December 8, 2023

RE: Amendment No. 1 to the Engineer's Report

Drainage District No. 14 Project No.: 0A1.124363

Map of Hypothetical Southern Route

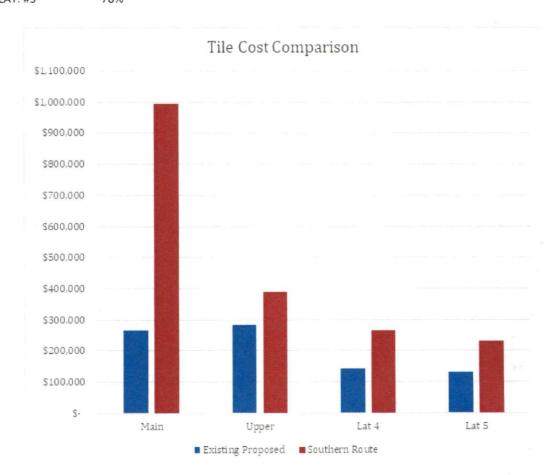
To drain south to the watershed's natural outlet would require approximately 5,200 feet of additional tile compared to the proposed Main tile. Assuming the same grade can be achieved as the 1914 tile, this new tile would need to be 42 inches in diameter to accommodate the lands north of 450<sup>th</sup> Street at the same capacity of the proposed 36-inch tile. To accommodate all the lands south of 450<sup>th</sup> Street that may potentially drain to it would require a 48-inch tile. Each proposed lateral would also require more length of tile. A table summarizing the additional lengths and costs is attached.
